Freightliner
Service Bulletin

SB-10056585-4176

General Information

The fuses on horizontally-mounted powertrain power distribution modules (PDM) may crack due to vibration. Use the instructions in this bulletin to reduce the level of vibration on the PDM.

Fig. 1, Wrapping the PDM Harness with Electrical Tape

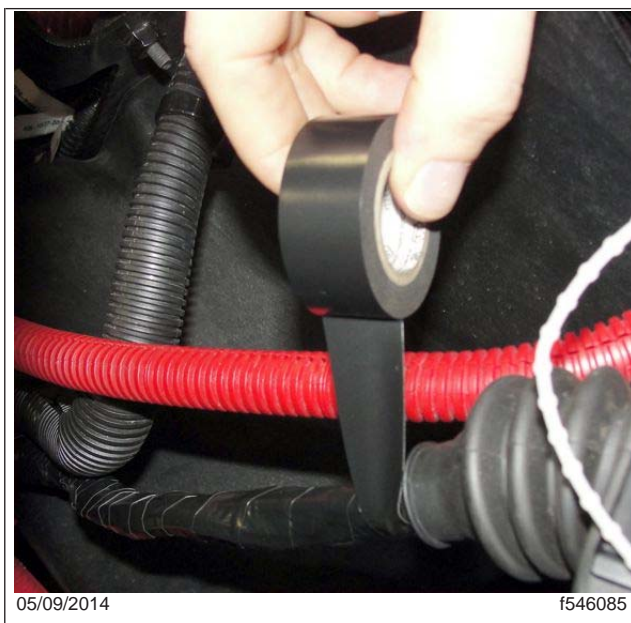
1. Park the vehicle, shut down the engine, and apply the brakes. Chock the tires.
2. Open the hood.
3. Remove the split loom from the PDM harness and discard.
4. Wrap a 6-inch (15-cm) length of the harness with electrical tape, starting at the base. See [Fig. 1](#).

Fig. 2, PDM Harness with a Drip Loop

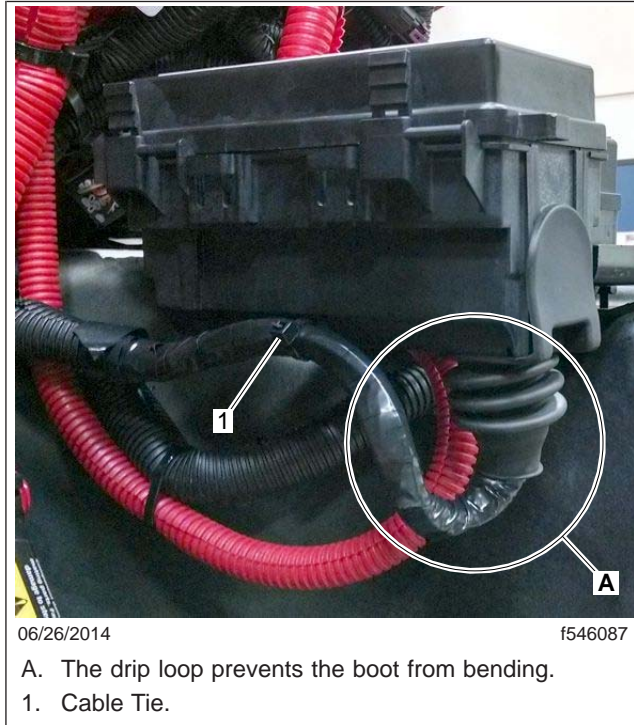
5. Secure the harness to the PDM using a cable tie.
 - 5.1 Feed the cable tie through the opening at the base of the PDM.
 - 5.2 Wrap the cable tie around the harness and attach the ends, but do not tighten.
 - 5.3 Form a drip loop with the harness so that the PDM boot is not bent or pulled by the harness.
 - 5.4 Tighten the cable tie and secure the harness tightly to the base of the PDM. See [Fig. 2](#).
6. Close the hood.

- A. The drip loop prevents the boot from bending.
- 1. Cable Tie.
